Subject: **Bid No. 8800-M7 – Accessibility Renovations – New Citizen Center / WPS**

ADDENDUM NO. 3

**1407A MAIN STREET
WORCESTER, MA 01603**

ENLARGED FIRST
FLOOR CEILING
PLANS

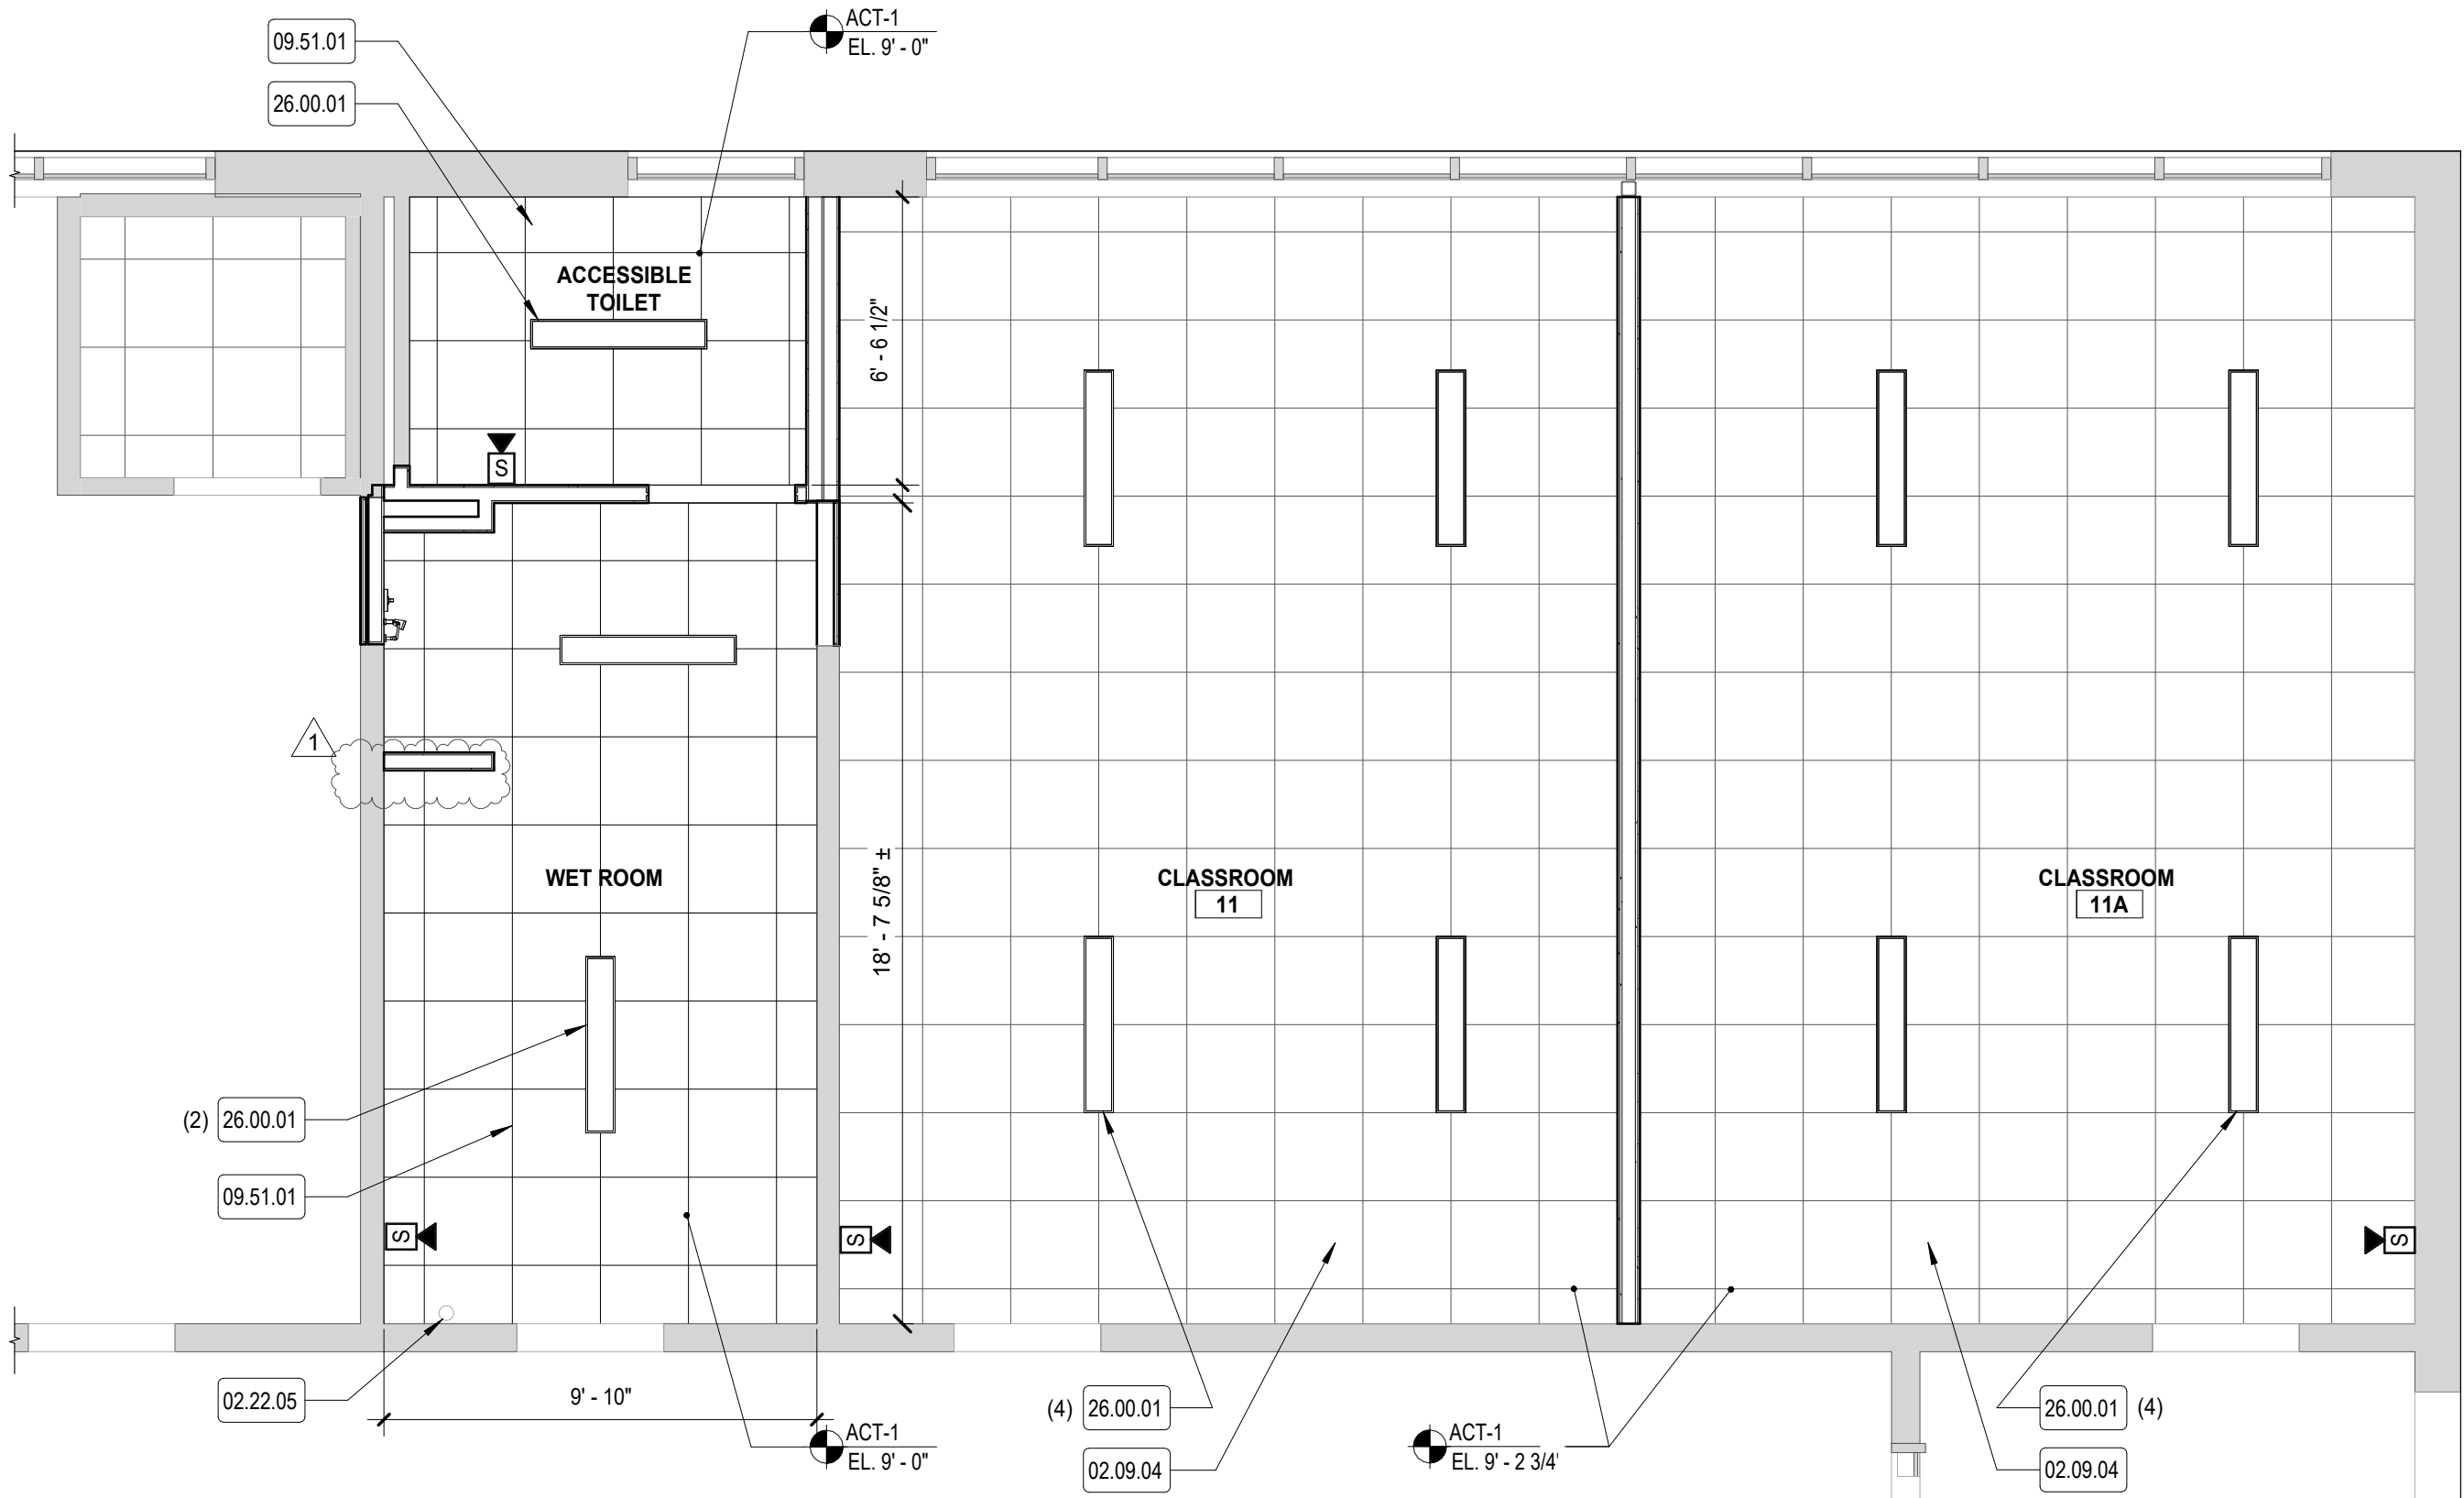
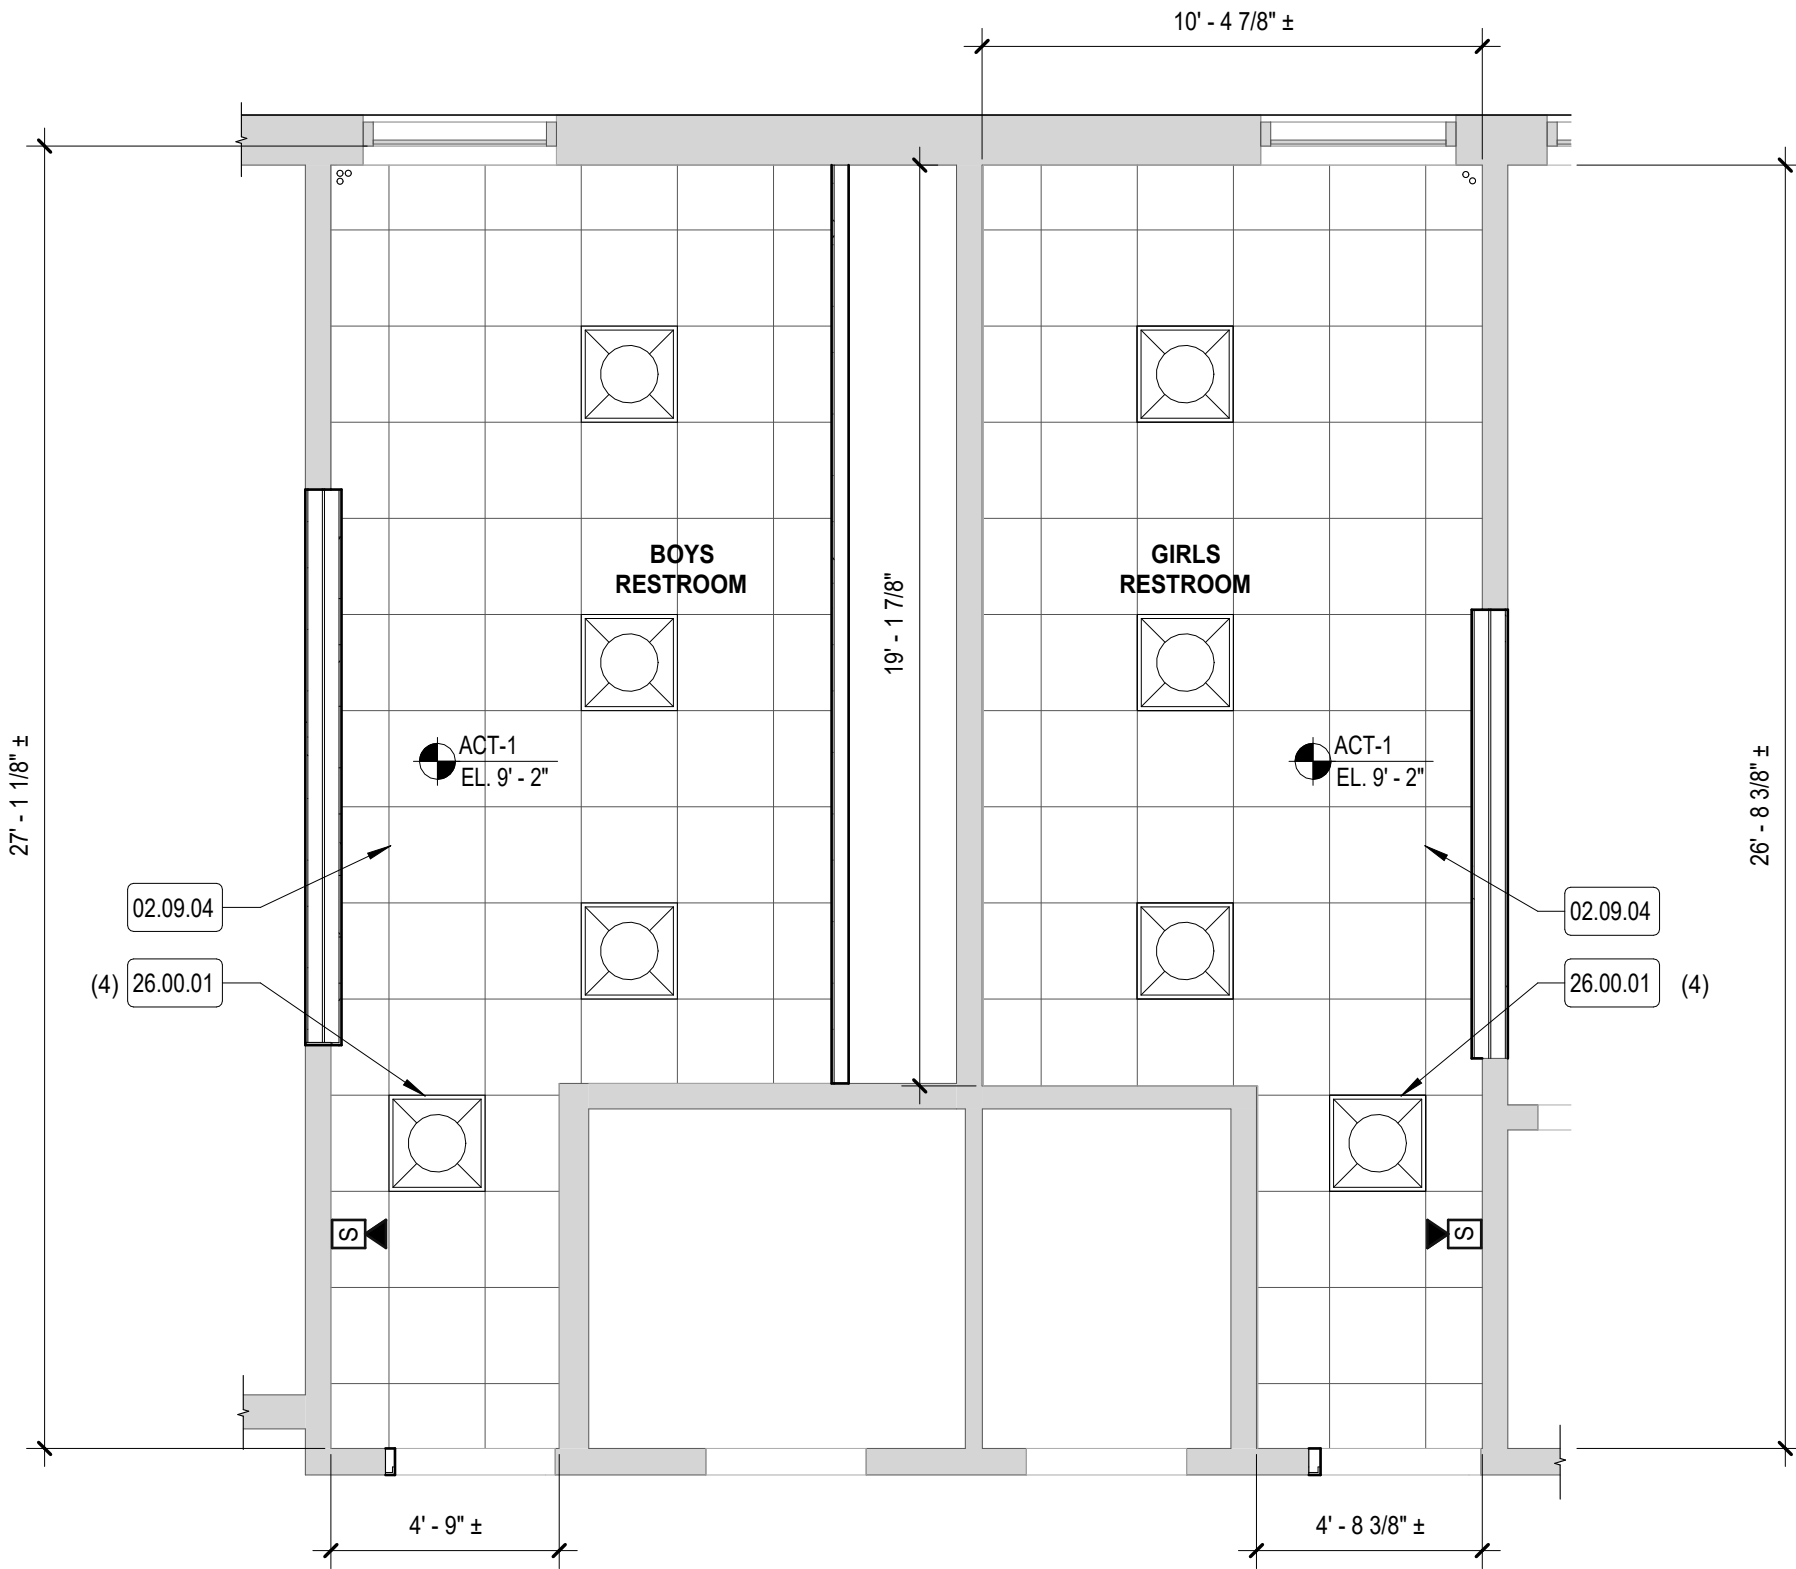
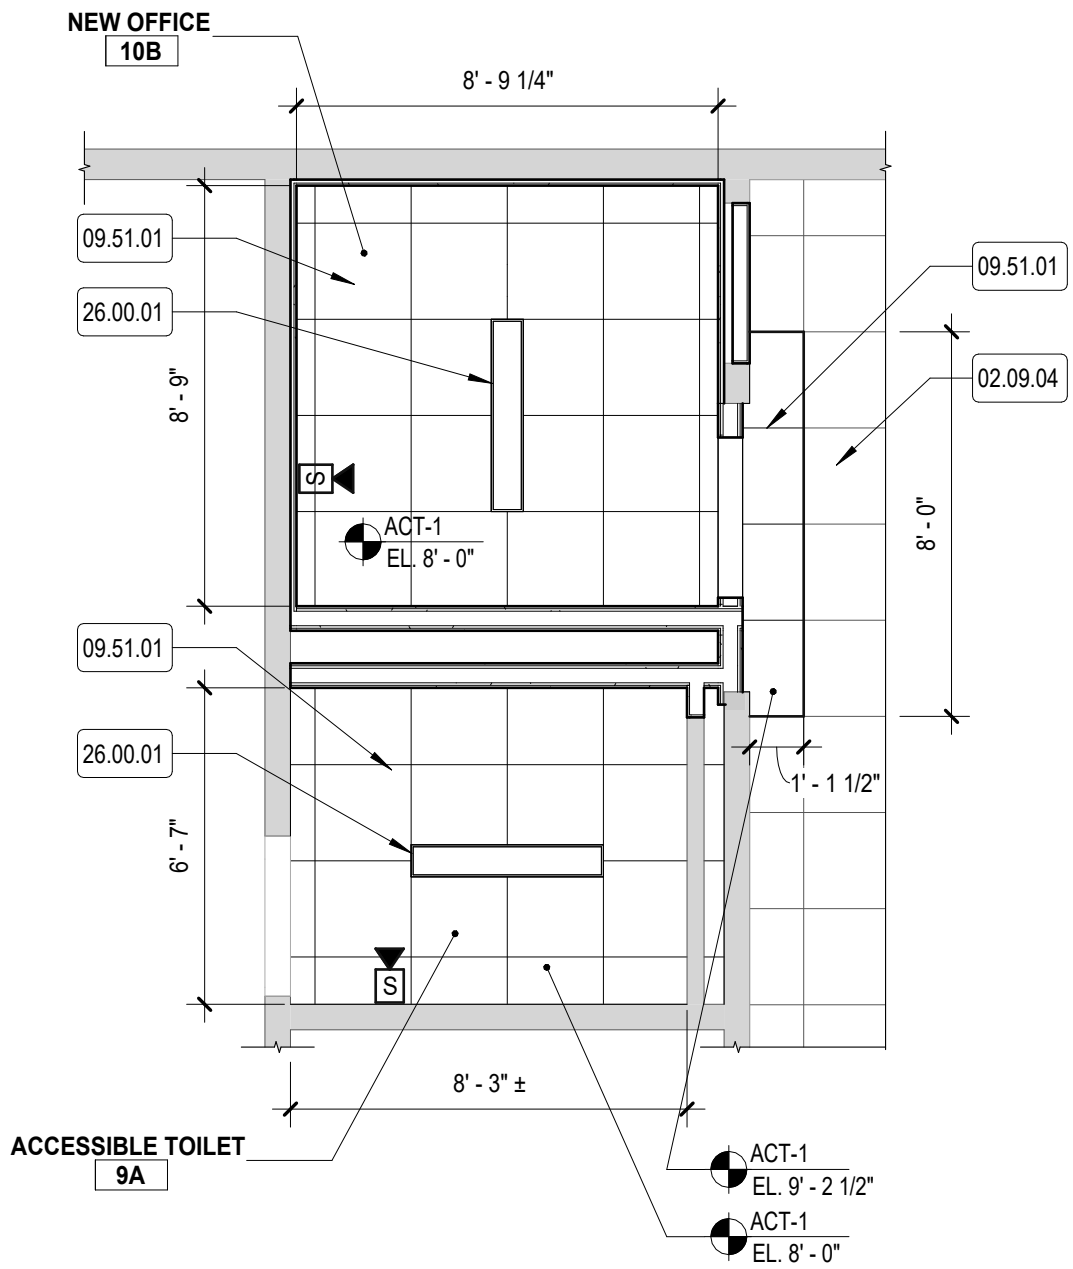
SHEET #	Change
A410	Revised design of shower in wet room - Revised dimensions - Revised wall mounted seat location - Added grab bars Added shower head location
A420	Corrected ACT layout
A431	Revised shower in wet room elevation
A701	Corrected Wet Room and Accessible Toilet floor base finish.
P200	Revised location of sink waste from life skills kitchen (see P303).
P201	Revised location of shower fixture in wet room.
P301	Detail 2: Added demolition of existing hose bibbs in gang toilet rooms.
P302	Detail 2: Added new hose bibbs in gang toilet rooms. Revised location of shower fixture in wet room.
P303	Detail 1: Clarified water to UB to come from drop to SK-2. Revised location of services to SK-1 & SK-2 coordinate with location of fixtures.
P400	Detail 2: Revise water hammer arrestor note to specify model. Detail 6: Add detail in its entirety.
M303	Corrected missing AC unit tag.
M304	Corrected missing AC unit tag.
